## Board of Zoning and Planning Staff Report

May 25, 2023 6:00 PM

1) Application Number: BZAP-23-10

Address: 2504 Bexford Place

Site plan and front aerial of 2504 Bexford Pl

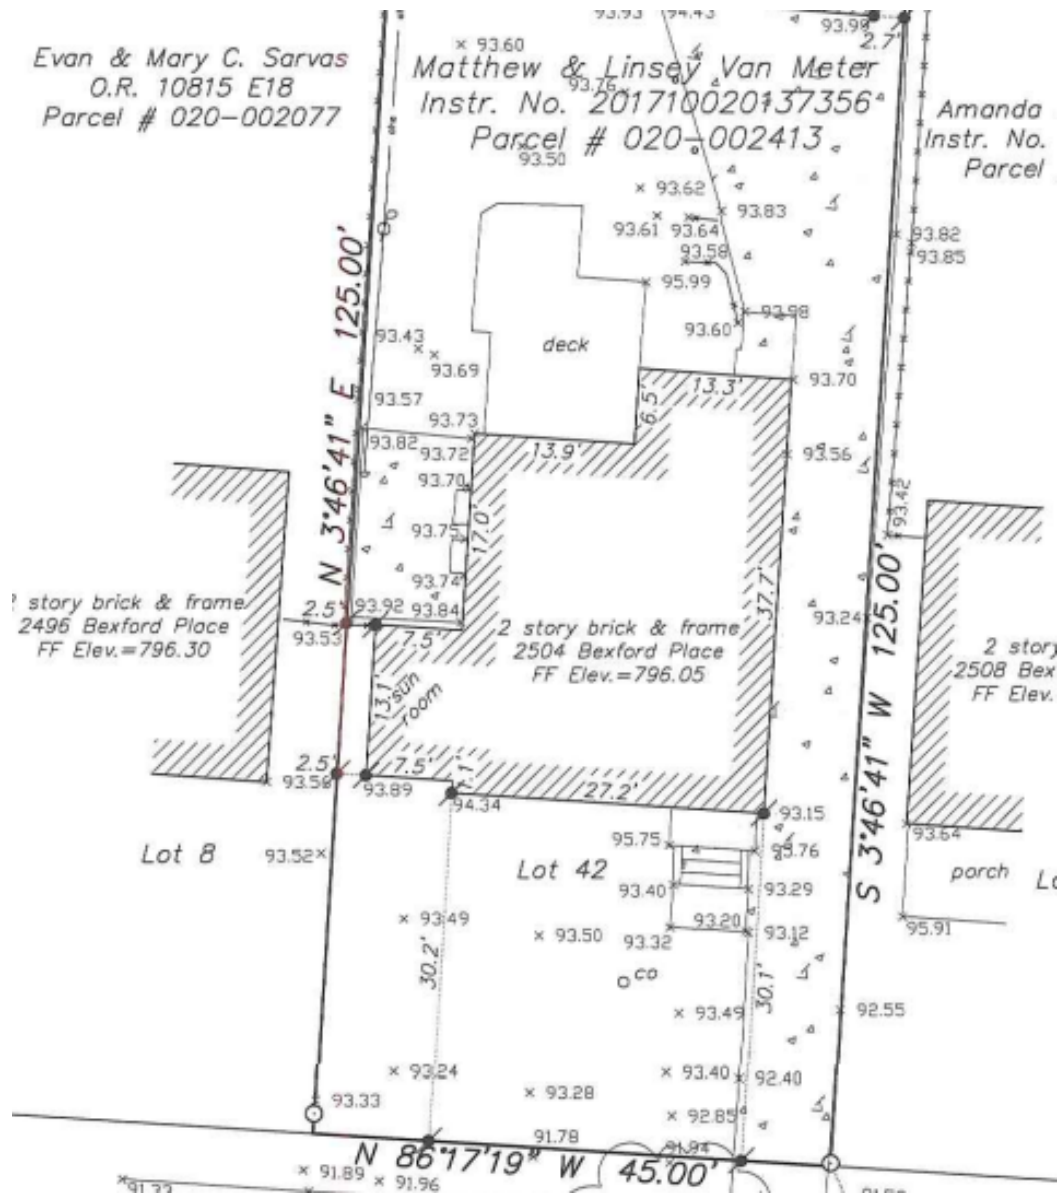
This is an existing greenhouse attached to the west wall of the principal structure and has an opening from the house to enter the space, as well as a door off the rear of the greenhouse.

R-6 Zoning requires a 7'6" side yard setback for this 45' wide lot. The greenhouse is located 2'6" off the west property line and would require a 5' variance from Bexley Code Section 1252.09, to allow a new addition to be constructed in the same footprint as the existing attached greenhouse.

If the Board finds it appropriate to grant a variance to allow the proposed addition. The applicant has indicated that the west (side) wall of the addition would have a 1-hour fire rating, due to the proximity to the side property line, to addresses the fire code, as it does not allow for openings in a wall less than 3' from a property line. The windows can only be located on the front and rear of the addition and why it is designed as proposed.

West façade of 2444 Bexley Park with existing 1-story attached garage

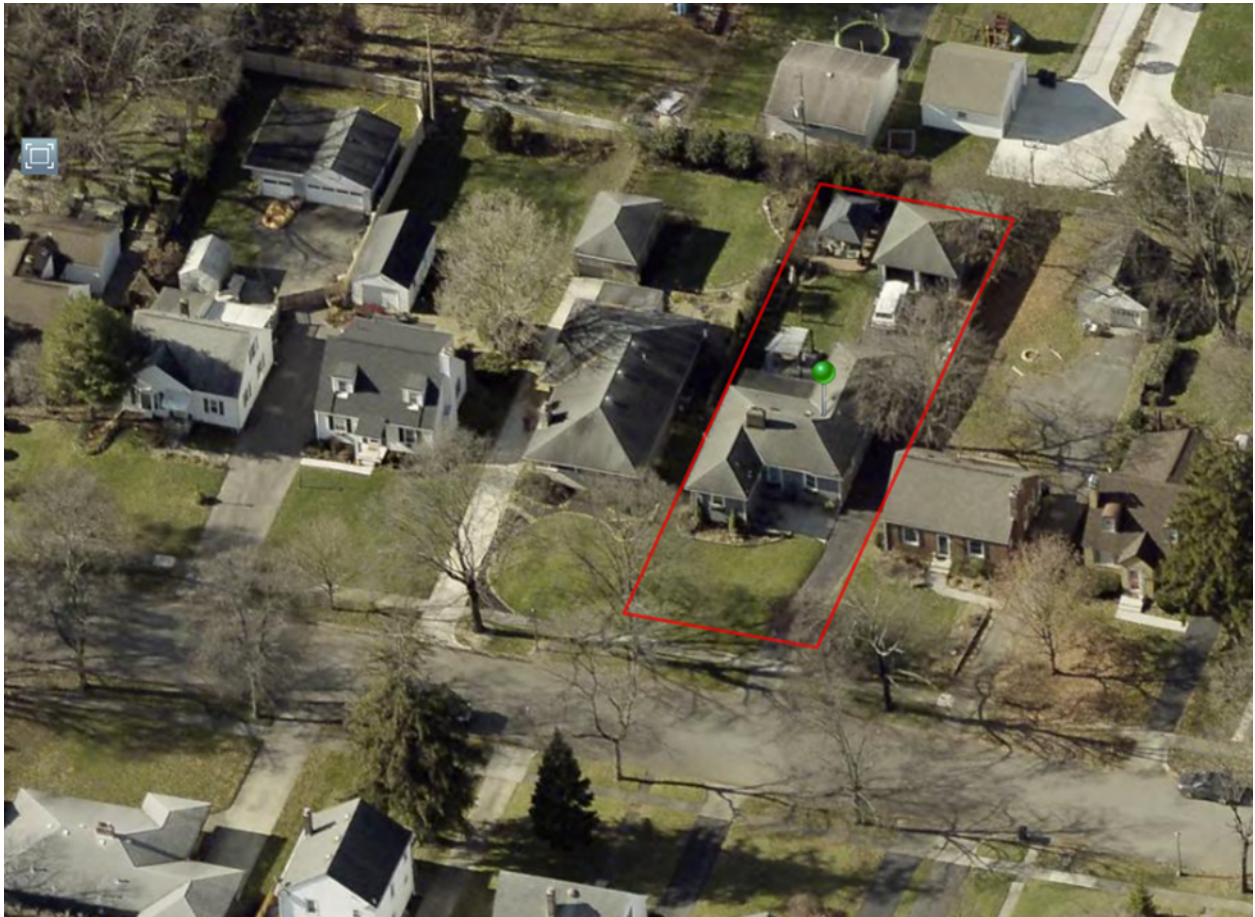
The existing attached (1-story ) garage is located 3' from the side property line and approximately 24' 6" from the rear property line.

The proposed attached garage with a 2<sup>nd</sup> floor is to be located 10' from the west (side) property line and 20' 6 ½" from their rear property line. Which would encroach 4' 6 ½" into the rear yard setback.

The overall massing of the structure is increased, but it is pulled away from the closest neighboring property. The ARB wanted Karen to share their design critique which encouraged the applicant to table the application but continue on for zoning review. If the Baord finds it appropriate to grant a variance they may want to remand final design approval back to the Architectural Review Board.

Powell Avenue – Property line is approximately 2’ behind the sidewalk

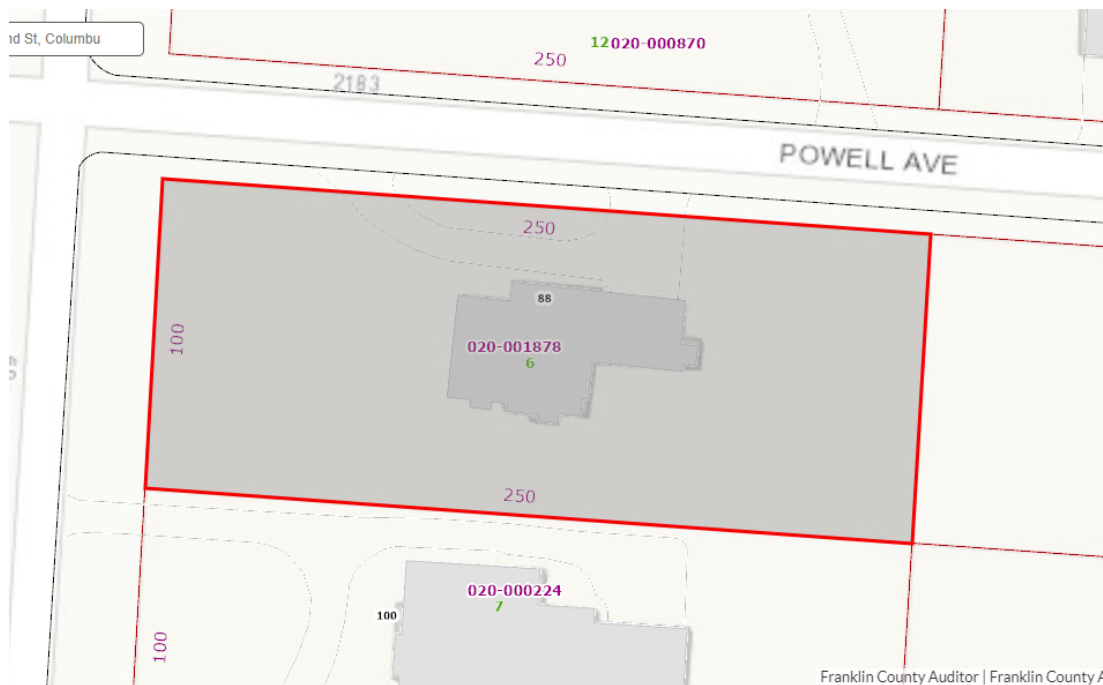
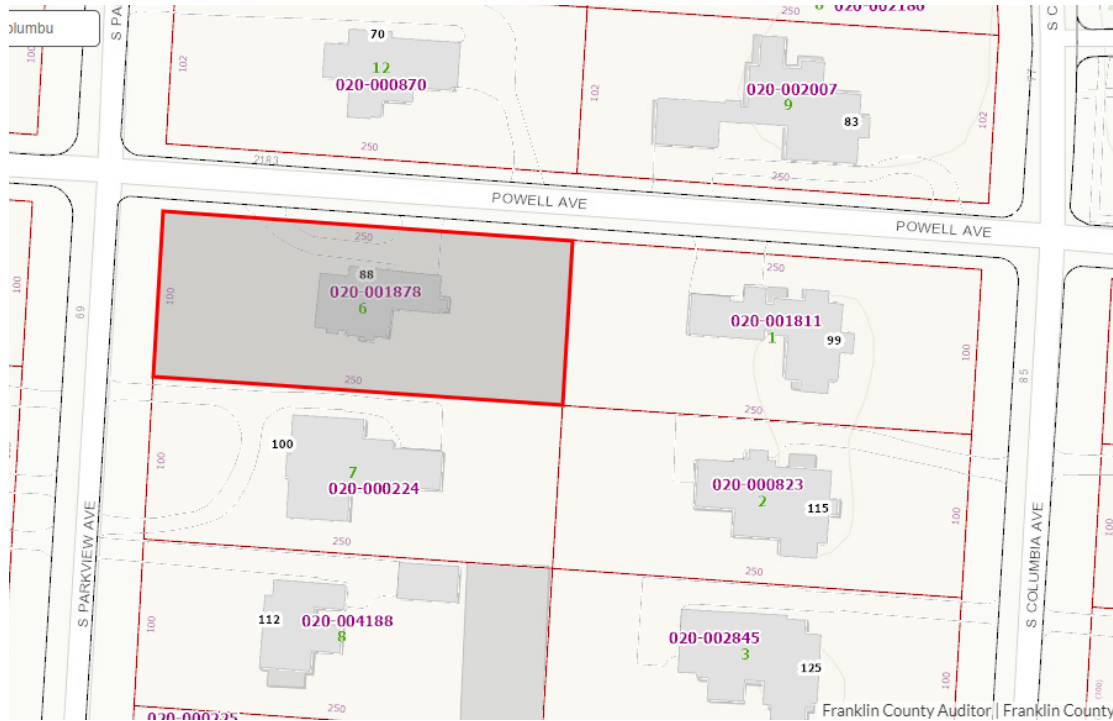
They would like to place a 72" high fence along the side property line, parallel to Powel for a distance of 68'. The property line is approximately 2' behind the sidewalk.

There is a row of trees along the side yard. The fence appears to be in the center of the row, with trees staggering both sides of the fence. Staff is concerned if the existing landscape is adequate. The fence would not change the visibility much, due to the number of existing tree & shrubs.

Should the Board grant a variance for the new plan staff would recommend that the landscape plan be subject to review and approval by the Landscape consultant, who may defer it to the Tree & Public Garden Commission.
